**ONSITE SANITATION City of Portland – Bureau of Development Services**  
1900 SW 4<sup>th</sup> Avenue, Portland, Oregon 97201 – 503-823-6892 – TTY 503-823-6868 – www.portlandoregon.gov/bds  
**SEPTIC REVIEW CERTIFICATION (Land Use/Planning)**

Description of proposed work for this Septic Planning Review M49 DWELLING - 3BR

Permit No. 21-038325-SE  
Date 4/20/2021

FOR: MIRANDA M49 RENEWAL  
 NO713  
 PARCEL 2 PROFILES AND DETAILS

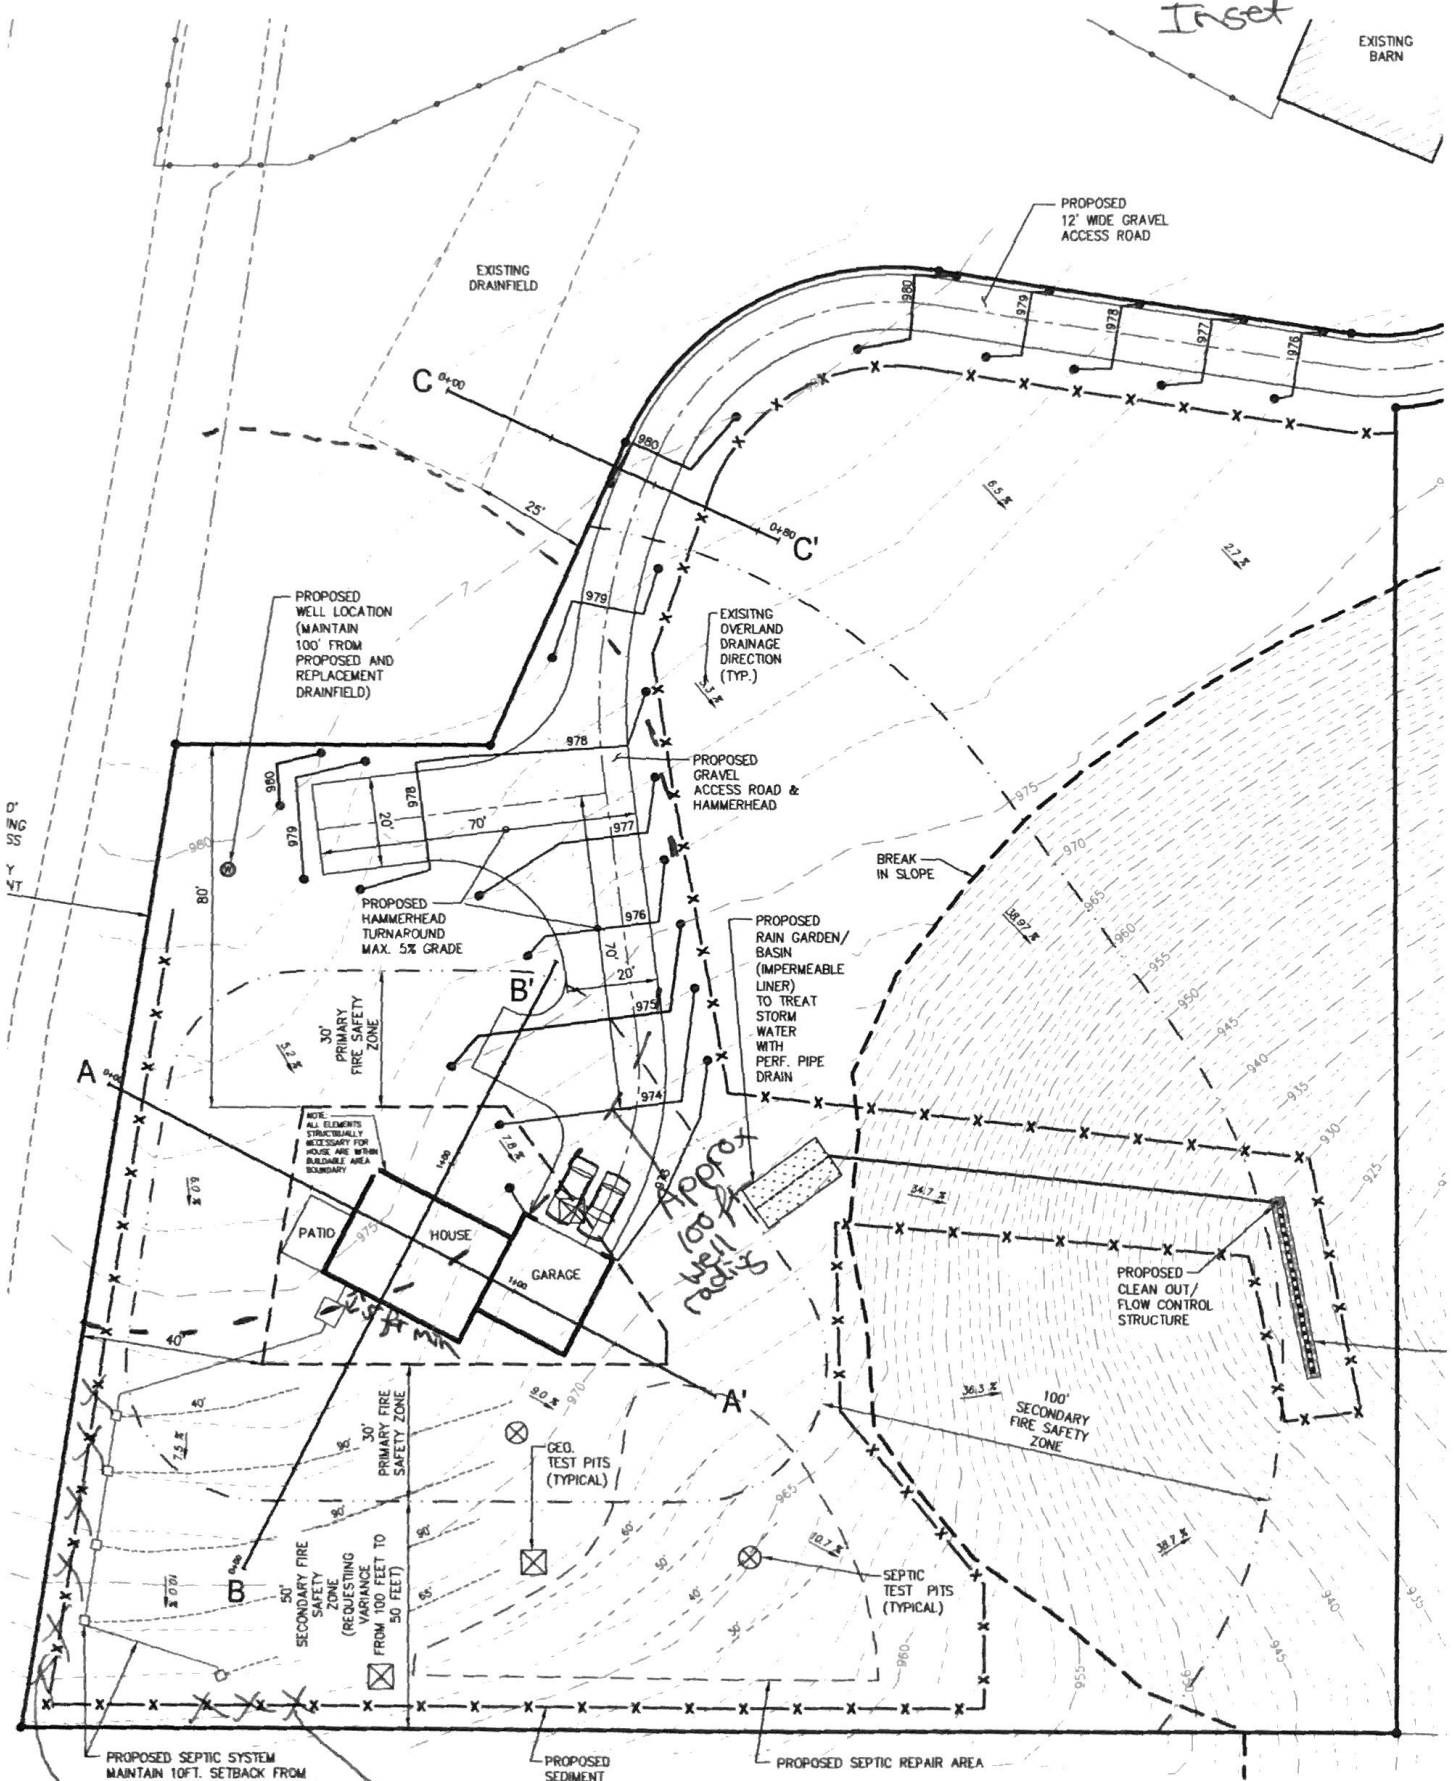
*Do not install silt fence - install at prop line, cannot interfere w/ 10 ft cap taper*

MAIN FLOOR PLAN  
 SCALE: 1/8" = 1'-0"

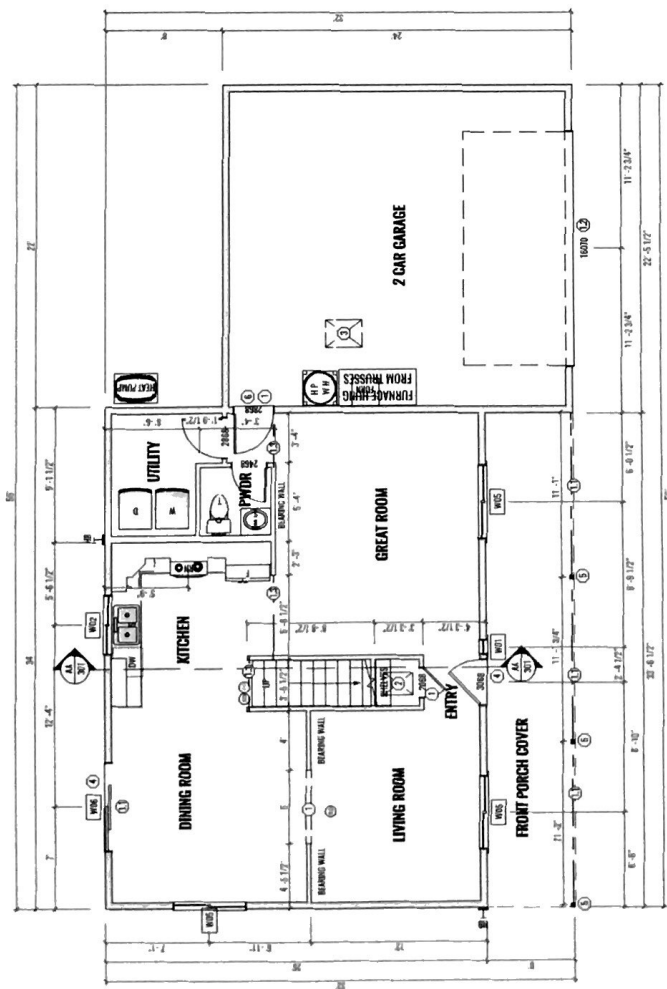
*3B possible*
